MONUMENT GLAMPING SITE PLAN
16315 RICKENBACKER AVE.
MONUMENT, CO 80132

SITE PLAN

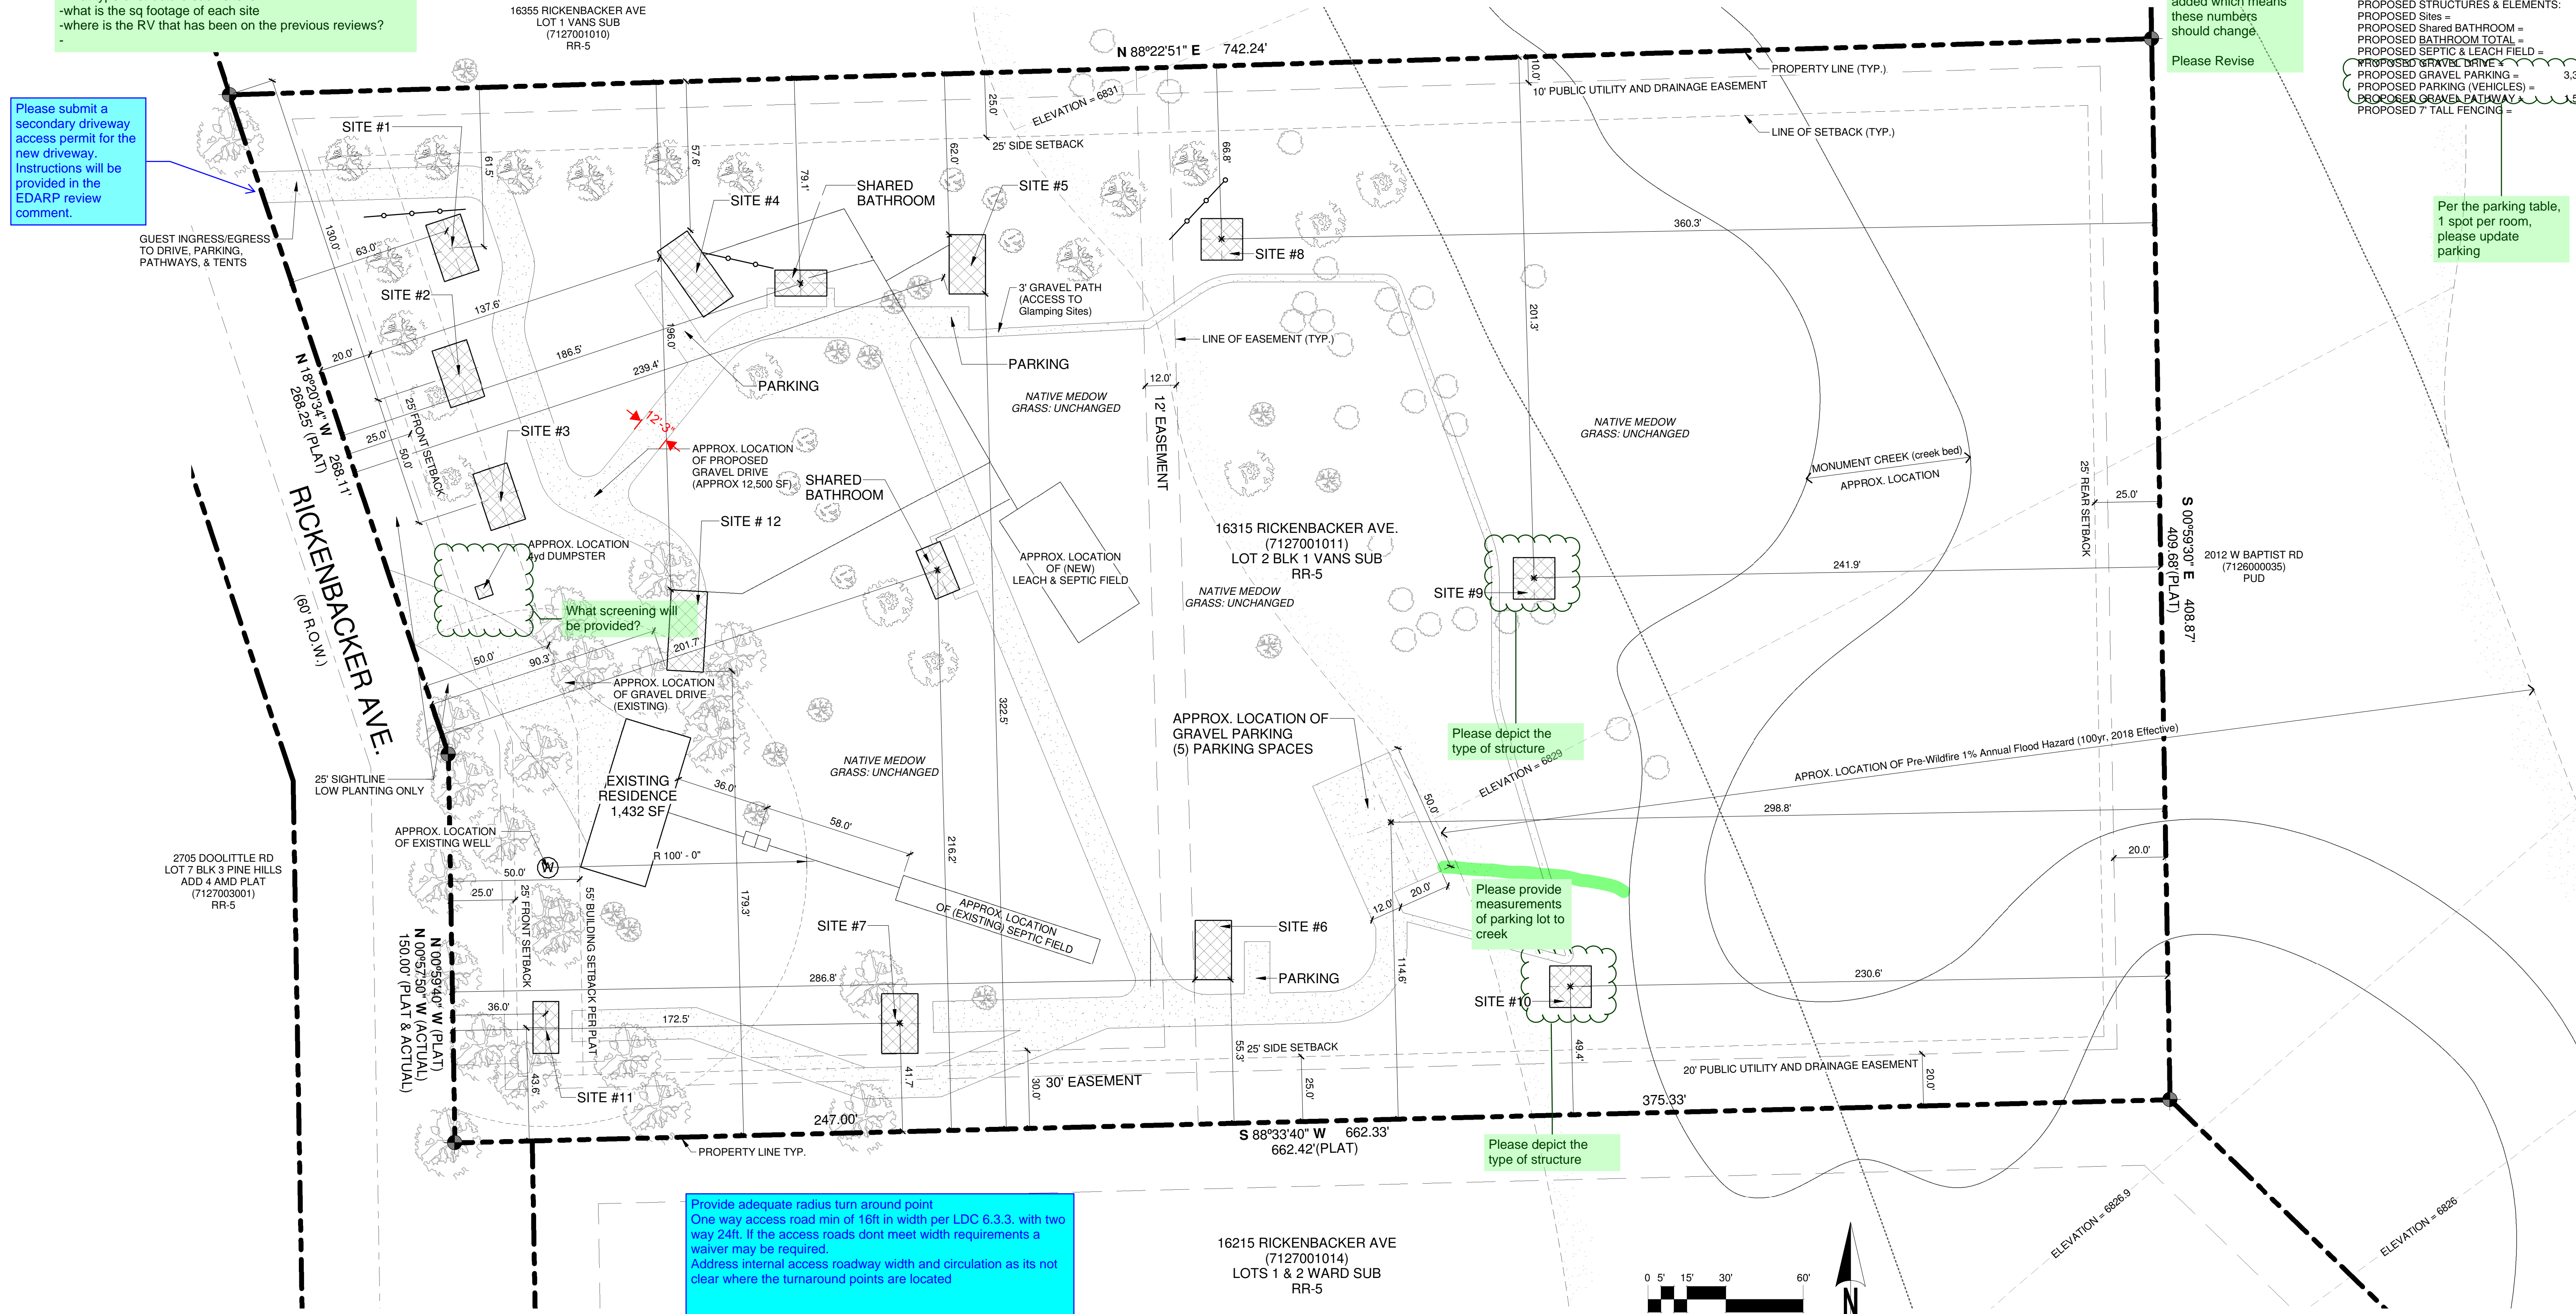
1432 + 480 + 3134 + 210 = 5,256
Please Revise

These numbers are the same as previous submittal and the proposal is asking for 4 more sites being added which means these numbers should change
Please Revise

Per the parking table, 1 spot per room, please update parking

Please include:
-what type of structure each site is
-what is the sq footage of each site
-where is the RV that has been on the previous reviews?

Please submit a secondary driveway access permit for the new driveway. Instructions will be provided in the EDARP review comment.

Please depict the type of structure

Please provide measurements of parking lot to creek

Please depict the type of structure

Provide adequate radius turn around point
One way access road min of 16ft in width per LDC 6.3.3. with two way 24ft. If the access roads dont meet width requirements a waiver may be required.
Address internal access roadway width and circulation as its not clear where the turnaround points are located
